**Public submission in respect to Mangrove Mountain Landfill – proposed extension**

1. Please find attached my submission in respect to the application by Verde Terra Pty Ltd (the **Company**) to renew its Environmental Protection Licence No 11395 (**EPL No 11395**) with the Environment Protection Authority (**EPA**). I understand the opportunity to provide a submission is the result of a direction from the Land and Environment Court (**LEC**) to enable the Court to make an informed decision. Accordingly, my submission is directed to the Court.

Figure 1. Illustrates the location of proposed Cells W, X, Y and Z. The yellow area represents Cell W, the brown area represents Cell X, the lilac area represents Cell Y and the blue area represents Cell Z (Source: Fig. 7: Approved Contours copied from the Leachate Management Plan 2009).

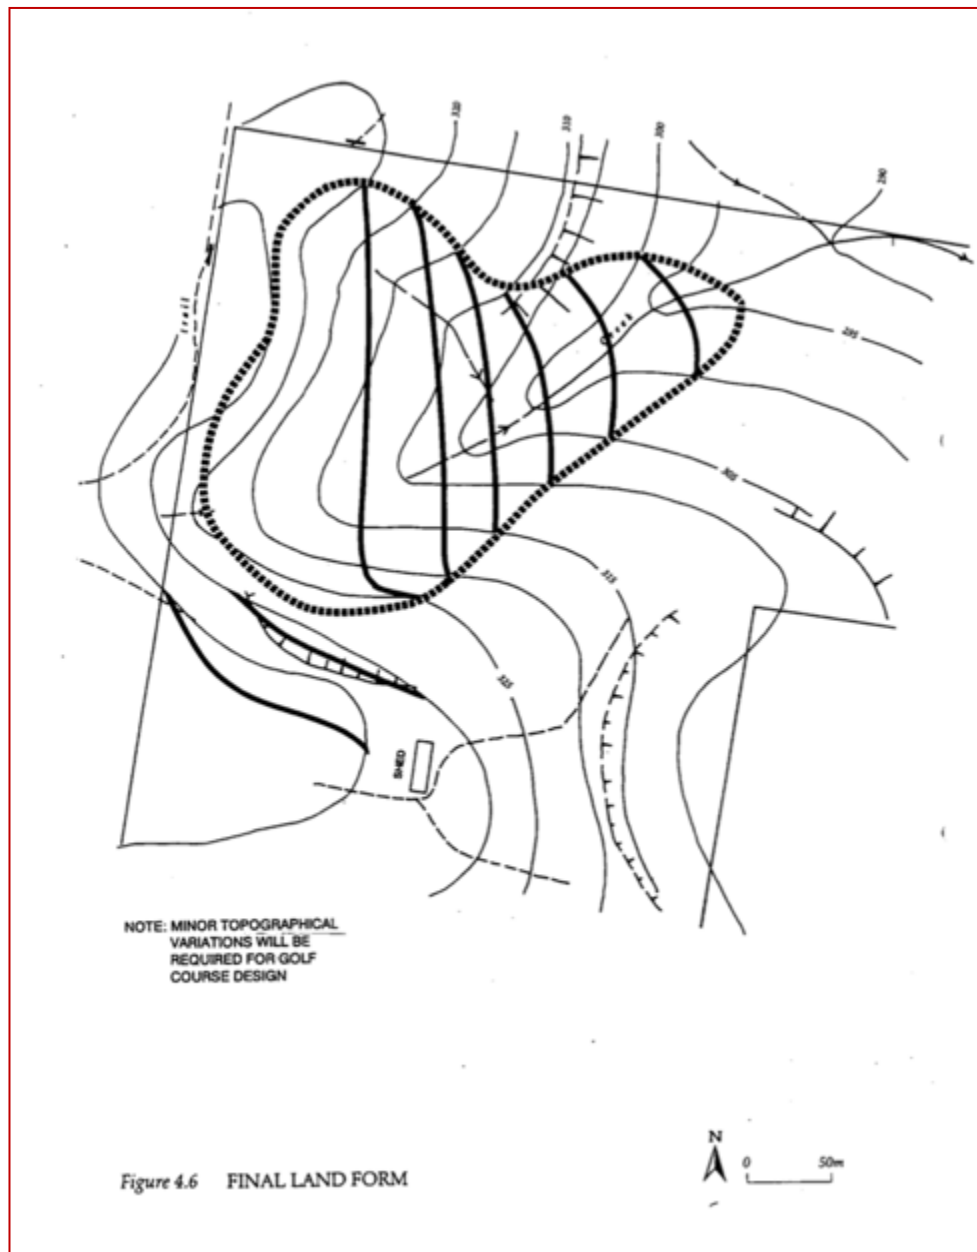
By comparing Figs 1 and 2 of this submission it is evident that the contour height of Area B has increased above the approved level of 310 m in the EIS and LEMP 1997. To illustrate the increase in height, by comparing the 310 m contour level between Figs 1 and 2 you will observe that in Fig. 1 it is altered at the northern property boundary. However, in Fig. 4, if you follow the 310-metre contour level you will observe that it is not adjusted until you have travelled 60 m south of the northern property boundary.

- The above text also refers to Fig 5 and Fig 7. A copy of Fig 7 of the LMP 2009 is labelled Fig 1 in this submission at page 22. Examining Fig 7 of LMP 2009 the following facts emerge:
  - Figure 7 is labelled “Approved Contours”. This is a false statement. The reason it is a false statement is because if you compare the approved contour levels in Fig 4.6 Final Land Form of the LEMP 1997 identified as Fig 2 in this submission at page 23 you will observe the height of the contour levels are different and the extent of the lengths of variation in contour levels is different.

- a. When examining Fig 1 in the submission, I would direct the Court's attention to the layout of Cells W, X, Y and Z with particular attention to the location of Cell Z which is located in the top left-hand side.
- b. When examining Fig 5 in the submission, I would direct the Court's attention to the fact that Cells W, X, Y and Z are to be excavated.
- c. As discussed in paragraph 68(e)(iv) this excavation is 300m in length, up to 190m wide and at the western end at Cell Y is approximately 48m deep. In the location of Cell Z due to the slope of the land the excavation would be up to 30m deep.

**Figure 6. Composite figure of the ground surface levels in September 2012 and the location of Cells W, X, Y and Z A** (Reference source: Annexure B1 on Heads of Agreement).

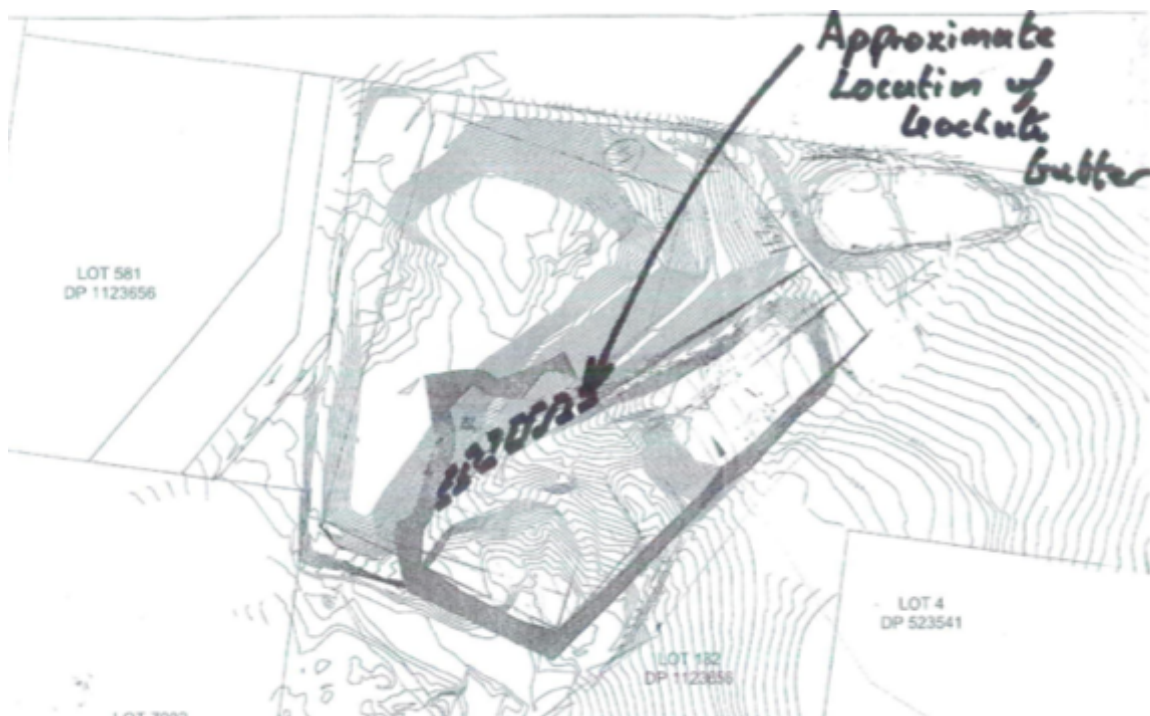
73. Taking into consideration the location of Cell Z in Figs 1 and 5 in this submission and comparing the location of Cell Z in Fig 6 of this submission it documents that Cell Z is currently under the southern section of the existing waste mound.

**Figure 7. Details of leachate transfer pipe and leachate holding pond in the Draft LMP 2013**  
(Reference source: LMP 2013 dated 1 November 2013 Fig 4).

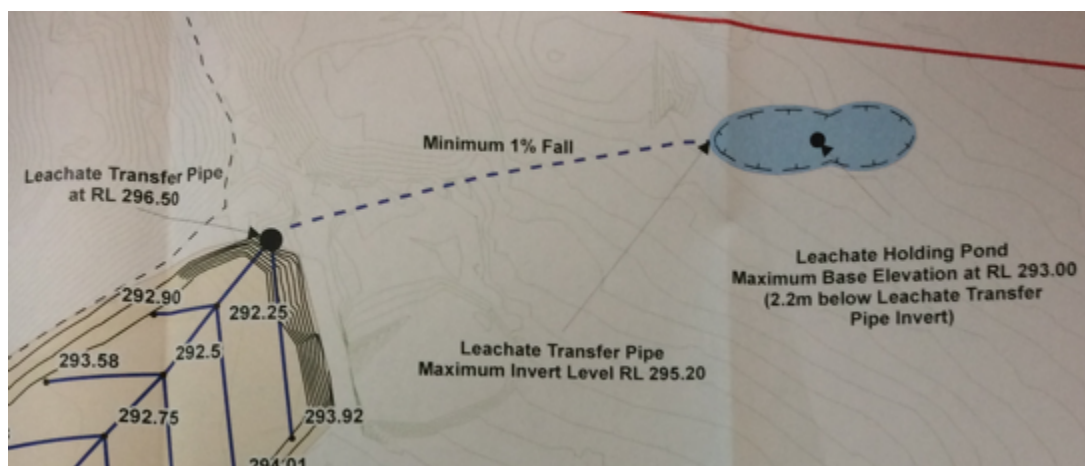
- c. In Fig 7 the Court will observe the base of Cell W is a RL 292.25. Yet the leachate transfer pipe is set at RL 296.50. This means the leachate transfer pipe inlet is set at 3.25 meters above the base of Cell W. As the leachate pipe outlet is set higher than the base of Cell

W the leachate drainage system is not gravity drained. As the leachate drainage system is not gravity drained this means that the draft LMP 2013 dated 1 November 2013 is not in accordance with the Heads of Agreement.

- d. When examining Fig 7, I wish to draw the Court's attention to the fact that the width, length, depth and volume of the leachate holding pond is not specified.
- e. As stated in paragraph 3, I left the fGCC in June 2014. At the time of my departure I do not recall having the opportunity to review the LMP 2013. Through GIPA applications I have been able to view Fig 4 of the LMP 2013 which is referenced in Order 2 in Court Order issued by the LEC on 29 August 2014.

**Figure 8. Details of leachate transfer pipe and leachate holding pond in the LMP 2013**  
 (Reference: Document 4 in the documents placed on public exhibition titled Class 4 proceedings  
 Sealed Court Orders dated 29 August 2014).

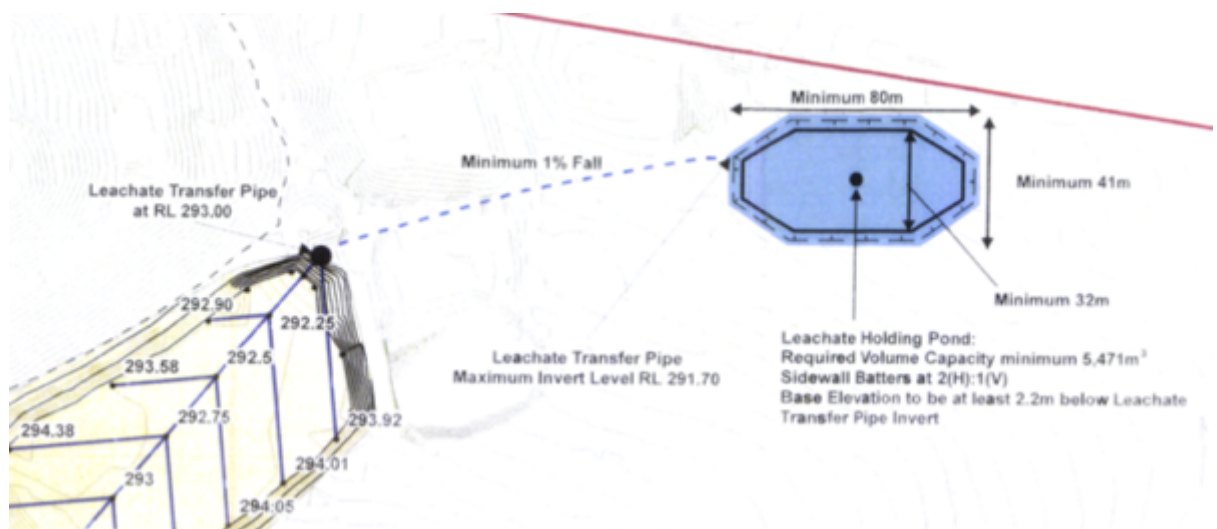
- f. I wish to request the Court to compare the different information presented in Fig 7 and Fig 8. In Fig 7, the Leachate Transfer Pipe is set at RL 296.50. In Fig 8 the Leachate Transfer Pipe is set at RL 293.00. In Fig 7, there is no width, length, depth or volume of the Leachate Holding Pond. In Fig 8, the Leachate Holding Pond width is 41m, the length is 80m the depth is at least 2.2m below the Leachate Transfer Pipe Invert resulting in a volume of 5,471 m<sup>3</sup> which is equal to 5,471,000 litres.
  - i. In my view either the fGCC staff or the consultant who prepared the LMP 2013 should have addressed the fact the existing leachate holding pond is grossly undersized.
  - ii. The LMP 2013 is the original document upon which the LMP 2014 dated Oct 2017 was prepared.

**Figure 9. Details of leachate transfer pipe and leachate holding pond in the LMP 2014 dated 6 November 2014**

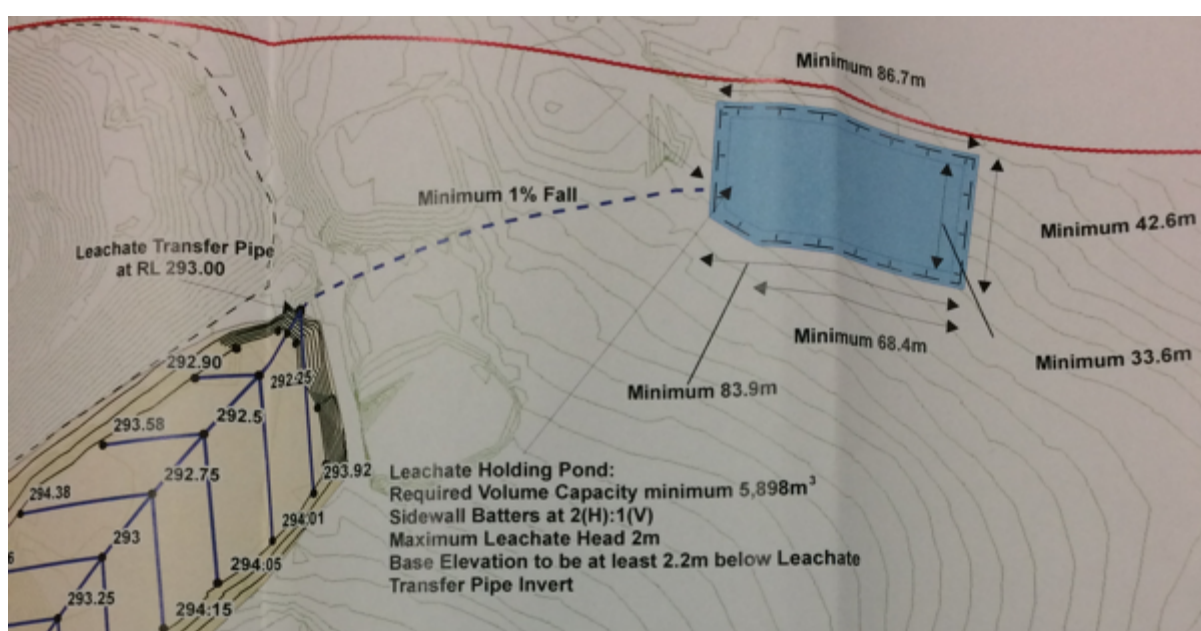
- b. The first information that I wish to direct to the Court's attention is Fig 9 which has been obtained from the LMP 2014 dated 6 November 2014. To understand the change, it is necessary to compare Fig 8 and Fig 9.
  - i. In Fig 8 and 9 the Leachate Transfer Pipe retains the inlet level at RL 293.00
  - ii. In Fig 9 the dimensions of the leachate holding pond have been increased and adjusted from 80m x 41m x 2.2m in Fig 8 to 86.7m x 42.6 x 2.2 in Fig 9.
  - iii. Increasing the dimensions of the leachate holding pond increases the capacity from 5,471 m<sup>3</sup> in Fig 8 to 5.898 m<sup>3</sup> capacity in Fig 9. This represents a volume of 5,898,000 litre capacity.

**Figure 6. Cell Z in Figure 2 of the LEMP 2014 dated 14 June 2016 is proposed in an area of the golf course that has already been remodelled (Source: LEMP 2014 dated 14 June 2016).<sup>(30)</sup>**

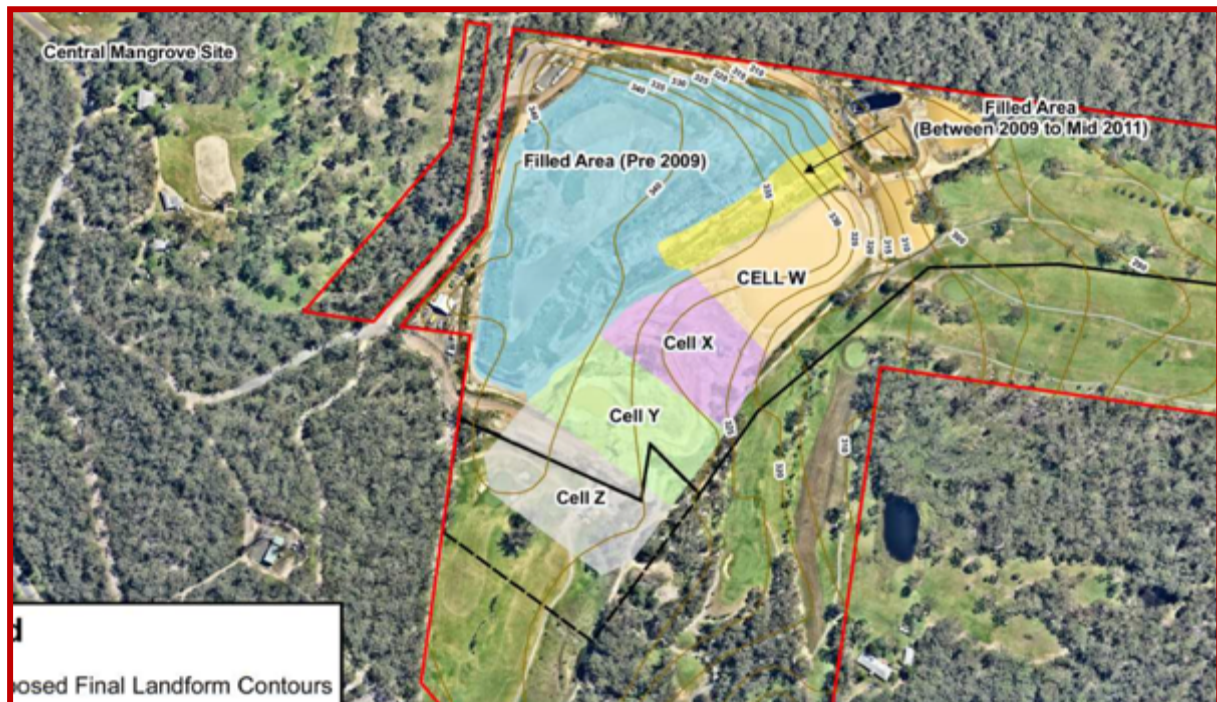
labelled Fig 6, you will observe that Cell Z is located in a location that has already been remodelled.

- ii. The question arises, why undertake excavation of VENM in a location that has already been remodelled? The only logical explanation to excavate an area of the golf course which has already been remodelled is to create additional void space. Creating additional void space means that more waste can be imported onto the site. In my view this represents a change in use.

- i. If one compares the location of Cell Z in Figure 1 in this submission at page 22 with Figure 6 of this submission the location of Cell Z has shifted 180 m in a south westerly direction. The only logical explanation for relocating Cell Z is to create a larger void space in Area B. Creating a larger void space in Area B means that more waste can be imported onto the site. In my view this represents a change in use.

**Figure 7. Proposed landform of the golf course for Area B in accordance with DA 23042/1998.**  
*(Reference source: Fig. 4.6 Final Land Form LEMP 1997).*

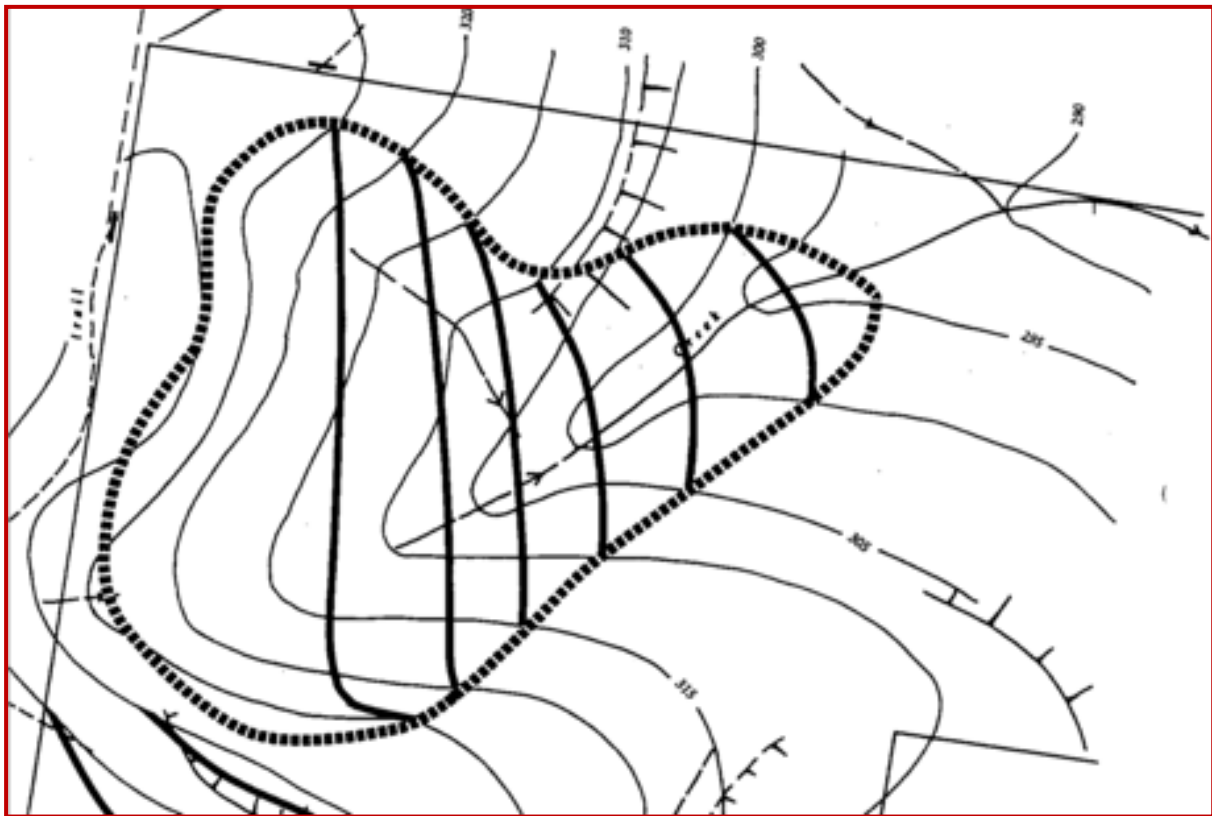
- ii. In Figure 7, the light lines represent the existing surface of the land prior to the commencement of any work. The heavier darker lines represent the proposed land surface in accordance with the proposed remodelling in DA 23042/1998.<sup>(31)</sup> The difference between the heavy and light contour lines indicates the intent of the remodelling was to fill in a small creek gully. Where the heavy 310 m contour line intersects the light 300 m contour line, it indicates that the depth of fill in this location will be 10m.

- v. When the final landform of the DA is compared with the Court Order, we find that the infilling of a 10-metre gully has changed to a 20-metre high hill (Figure 8). Instead of removing steep land from the golf course, as illustrated by the proximity of the contour lines, the slopes around the new hill are very steep. The slope of the northern side of the waste mound between the 340 m contour level to the 320 m contour level has a slope of 48.5%<sup>(34)</sup>, which results in an angle of 25.87 degrees. So rather than removing steeply sloping land from the golf course, the Court Order is creating even steeper slopes on the golf course over larger areas. Consequently, the primary purpose of remodelling the golf course to remove steeply sloping land to increase the playable area of the course has to all intents and purposes been abandoned.
